Access Compliance Report

Public Rights-of-Way (Curb Ramps)

Intersection ID: 14281	Main Street: E_KINGSTON_AV	Cross Street: LYNDHURST_AV	Location: E
ADA ID: A033EB15F313	Ramp Type: Directional1	Initial Pass/Fail: Fail	Overall Compliance: No
		Severity Score: 1.25

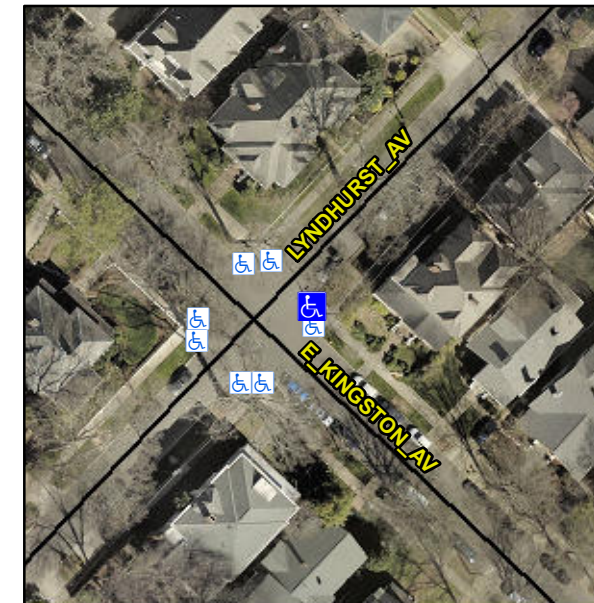
R304.5.3

Remove & Replace Entire Ramp.
